**PARK CITY MUNICIPAL CORPORATION
PLANNING COMMISSION**

CITY HALL, COUNCIL CHAMBERS
MAY 8, 2013

Planning Commission Staff Report

Subject: Green Park - Cohousing
Authors: Francisco Astorga & Anya Grahn
Project Number(s): PL-13-01831 & PL-13-01832
Date: May 8, 2013
Type of Item: Administrative - Plat Amendment & Conditional Use Permit Work Session Discussion

lower & main level floor plan
HDDR-009
february 4, rev. march 5, 2013

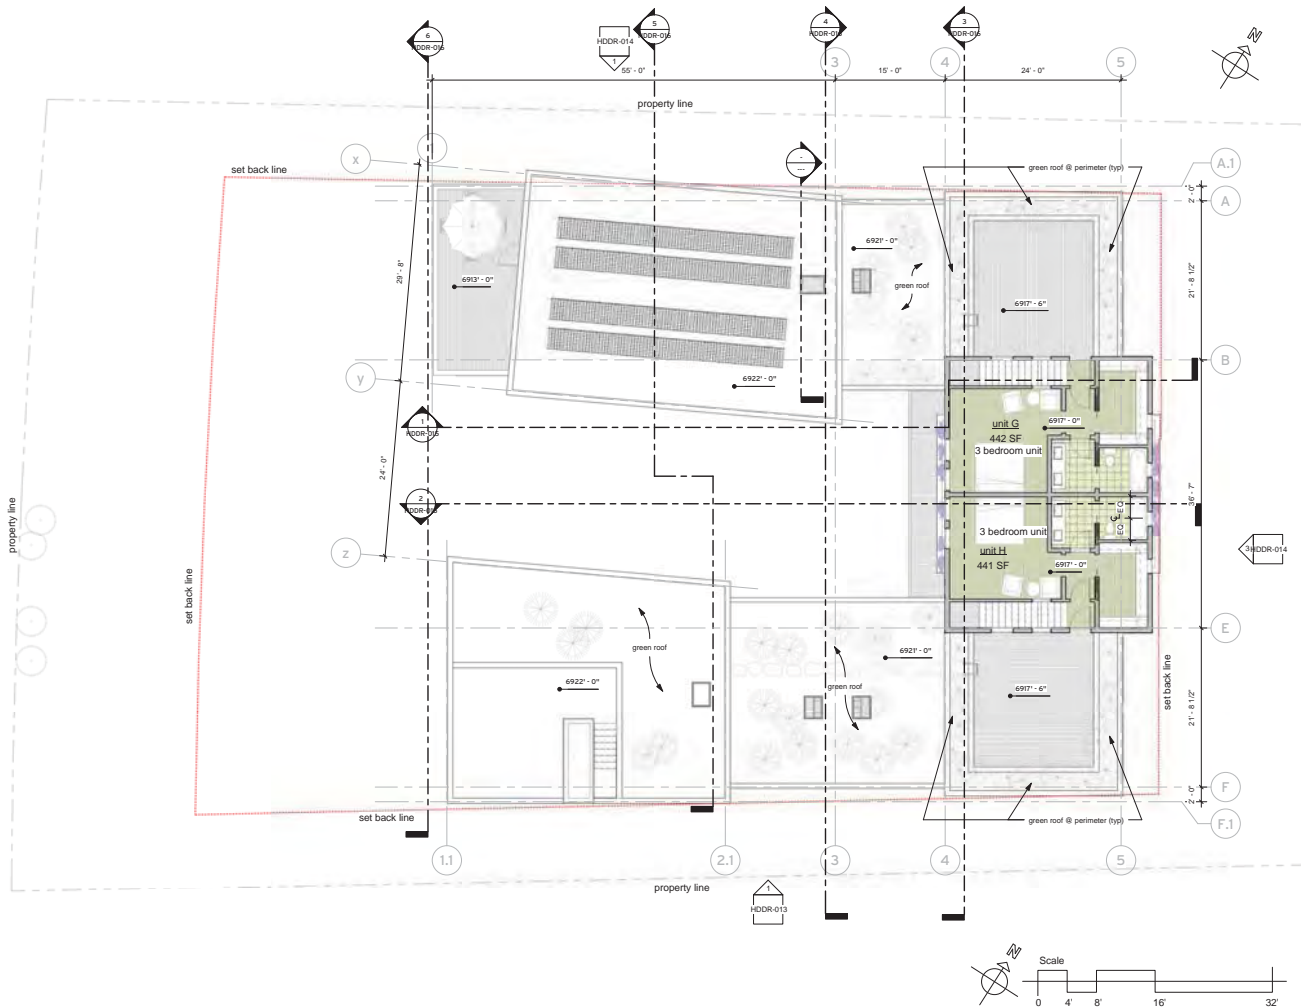
The applicant intends to provide six (6) garage parking spaces at the rear of the property, facing Sullivan Road. An additional eight (8) parking/driveway spaces will be provided in tandem configuration to the garages.

No ADA parking spaces are currently proposed in the plans.

Parking designs, which necessitate parking one (1) vehicle directly behind another, not perpendicular to each other, are permitted only for Single Family Dwellings, Accessory Apartments, and Duplex Dwellings in all zoning districts. In any Zoning District where the Front Yard is twenty feet (20') or less, both Parking Spaces must be perpendicular to the Street, unless there is an adequate landscaped buffer between the Street and Parking pad, subject to review by the Planning Director.

roof plan
HDDR-012

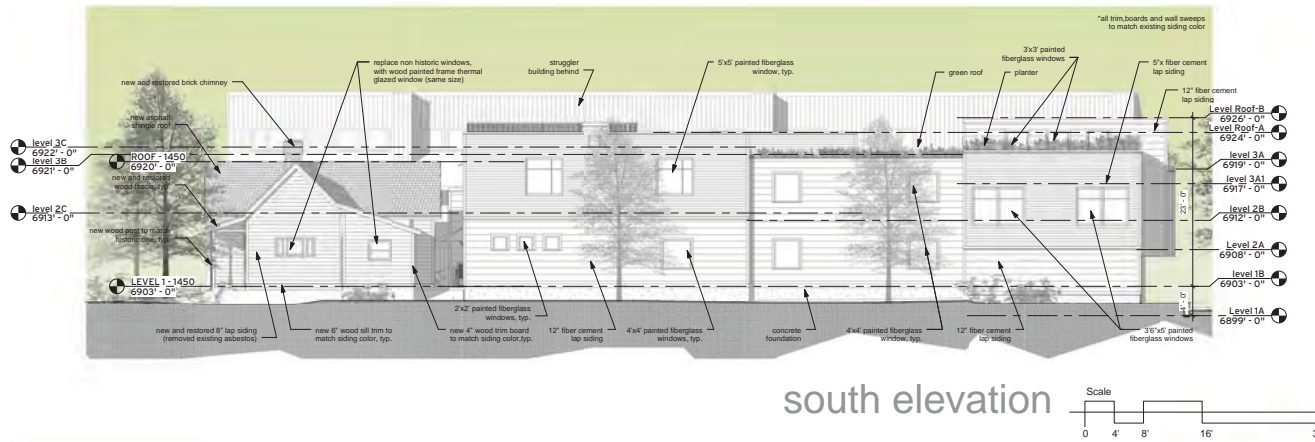
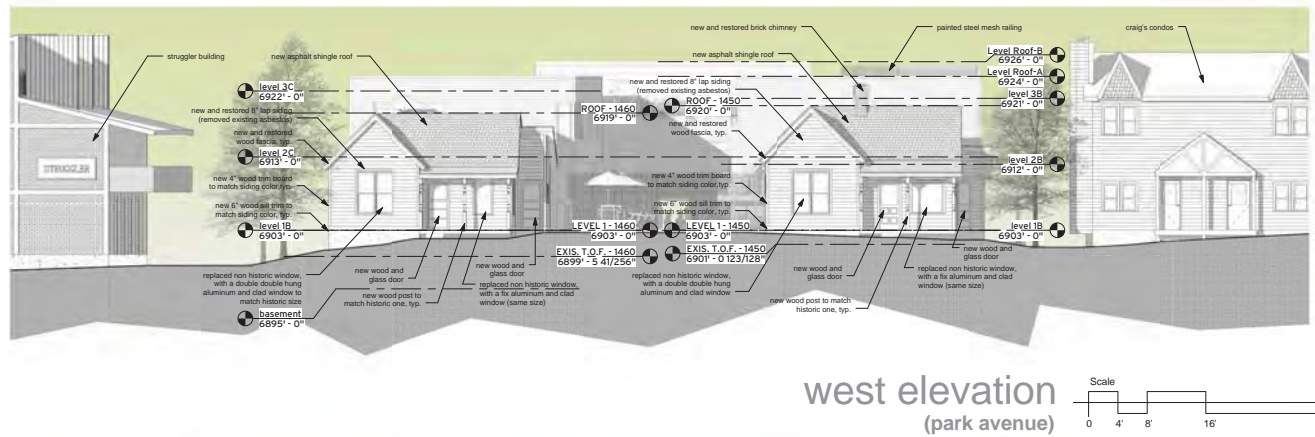
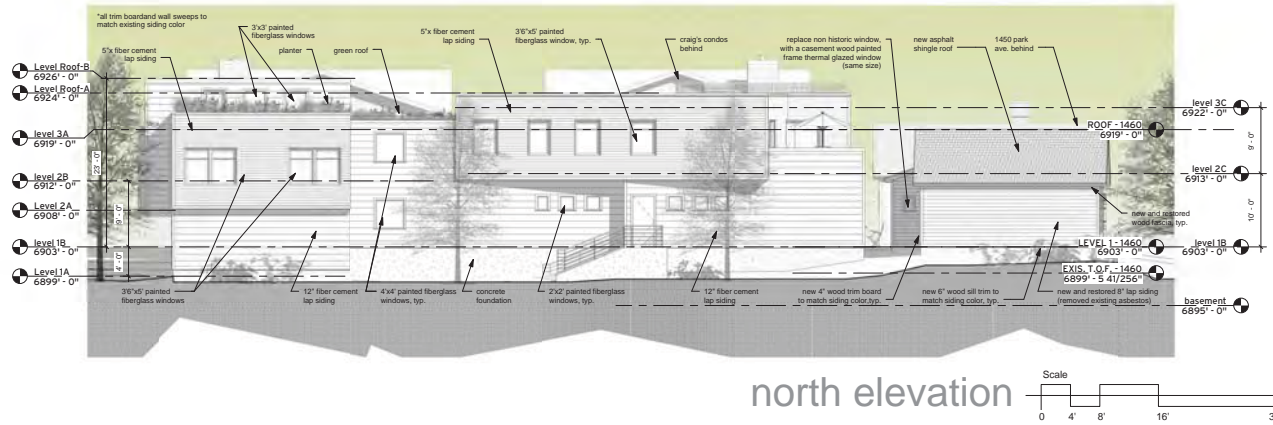
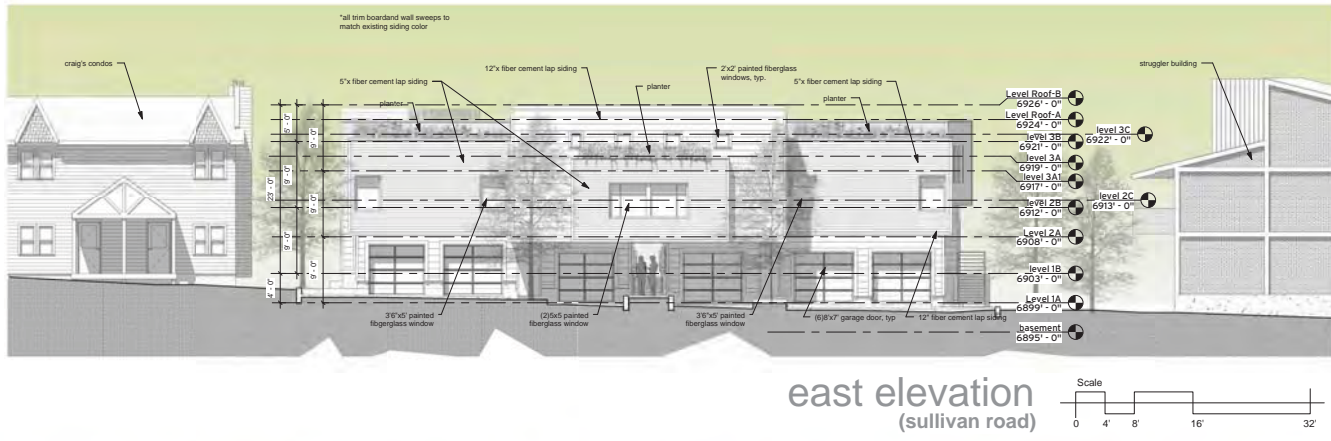
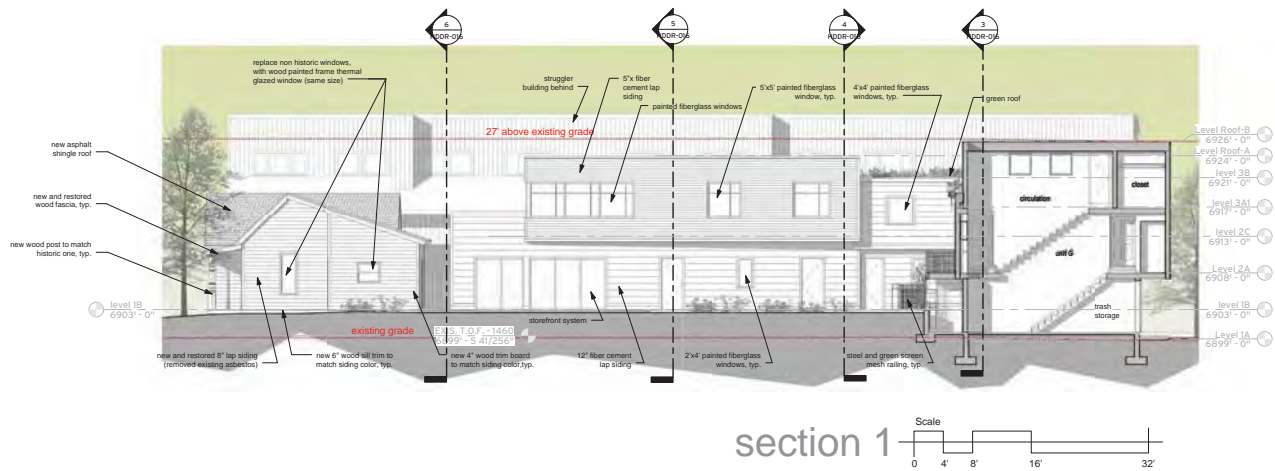
Sullivan Road: The six (6) garages on the main level are on the same building plane currently meeting the minimum front yard setback of twenty-five feet (25'). The second and third stories have a pop-out feature overhang towards Sullivan Road which breaks up the mass.

Plans that keep the Front Yard Setbacks clear of parking and minimize parking impacts near intensive Uses on Sullivan Road are positive elements of any Site plan. **Does not comply.**
